Re: Mountain View Landfill – Final Grading Modification

Based on requirements in R315-311-2(1)a, Mountainview Landfill, Inc. is requesting a Major Permit Modification for changes to the final grading plan. The drainage plan and other items associated with the existing permit will remain unchanged.

MOUNTAIN VIEW PERMIT MODIFICATIONS  
FINAL GRADING PLAN

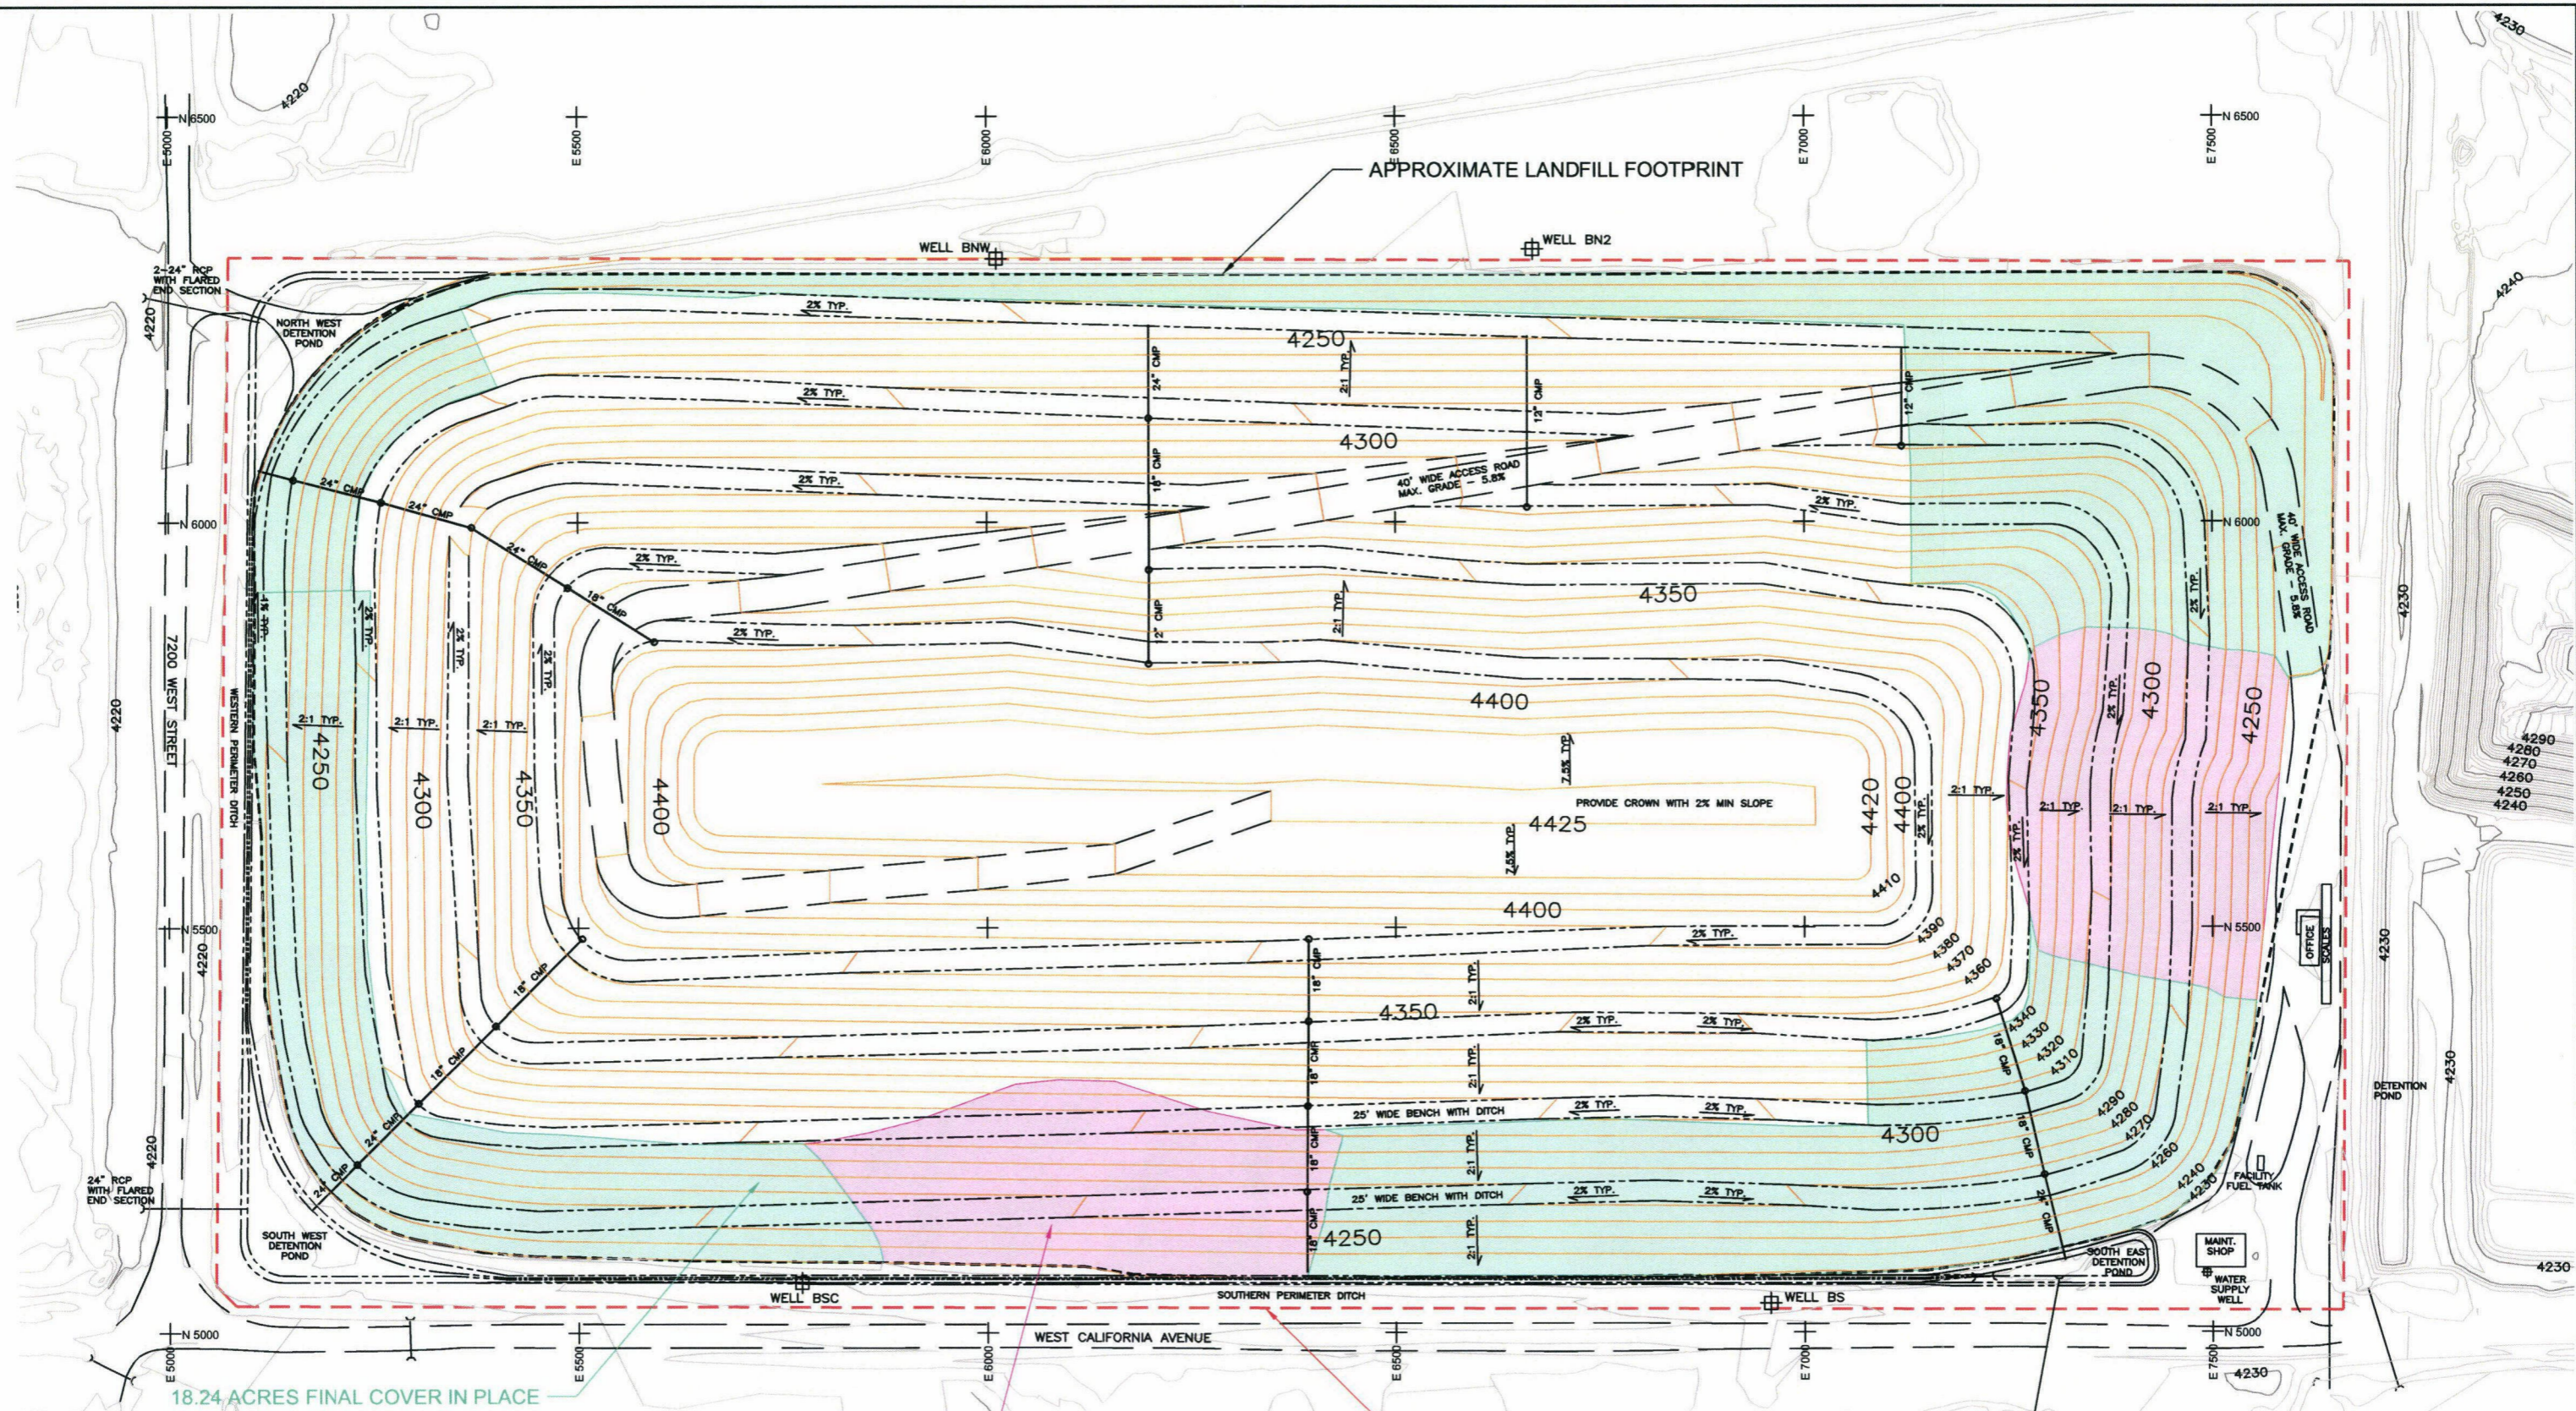
These variations in the slope cause operational issues because they decrease the amount of maneuverable space on top and are also an inefficient use of the landfill footprint. In order to alleviate these issues, it is proposed that the slopes in the portions that vary from the 2:1 side slopes be straightened to conform with the rest of the slopes at the facility. This will have no adverse effect on the functionality of the original design and will mitigate the issues of maneuverability and air space inefficiencies. The proposed revisions to the grading plan will also result in the removal of the two knoll design feature on top of the facility and replace it with a single wider top deck that still reaches the same approximate elevation of 4425 feet with a minimum 2% slope for drainage. Only revisions to the final grading are proposed which means that the previously approved design for the final cover, downdrains, grass-lined benches, and perimeter drainage will remain the same.

2018. The proposed design changes increase the remaining capacity to 1,207,255 cubic yards. This will add several more years to the design life of the facility.

The revised final grading plan drawing is the only part of the existing permit that requires updating as part of the permit modification. This letter provides the background and basis for approval of a permit modification from the Utah Division of Waste Management and Radiation Control (DWMRC).
